Docket Item #18
BAR CASE # 2005-0186

BAR Meeting
September 7, 2005

ISSUE: Construction of a new two story addition at the side and the addition of a second story to an existing one story structure at the rear of the house

LOCATION: 707 South Lee Street

Figure 1 - Proposed north elevation

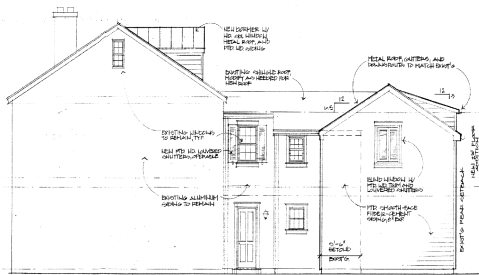
Visible surfaces of the new additions are to be clad in fiber cement siding and standing seam metal roofing. Windows and doors as well as casework is to be wood. A blind window opening with closed shutters is proposed for the exposed portion of the north elevation of the addition to relieve the scale of the otherwise large expanse of wall adjoining the property to the north.

Figure 3 - Proposed west elevation

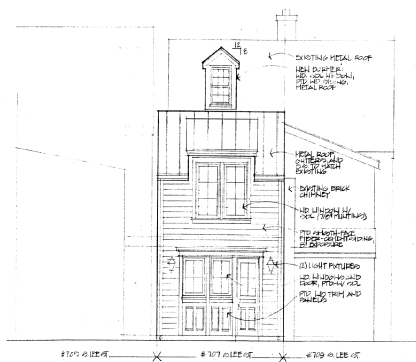
The newly created west elevation of conjoined flounder and north side addition would be defined by the west pitch of the cross gable roof, with a shed-roofed dormer containing a pair of what appear to be casement sash. The lower level of this new elevation would have a three bay element consisting of a pair of windows above panels and a single four light glazed door with matching panels, the whole within a simplified common entablature. A traditional gabled dormer is proposed for the west pitch of the gable roof on the main block of the house.

A basic concern is the character altering nature of the two story infill addition and the proposed new west elevation, both of which completely obscure, if not obliterate as well, any sense of the original flounder form, profile or proportions.
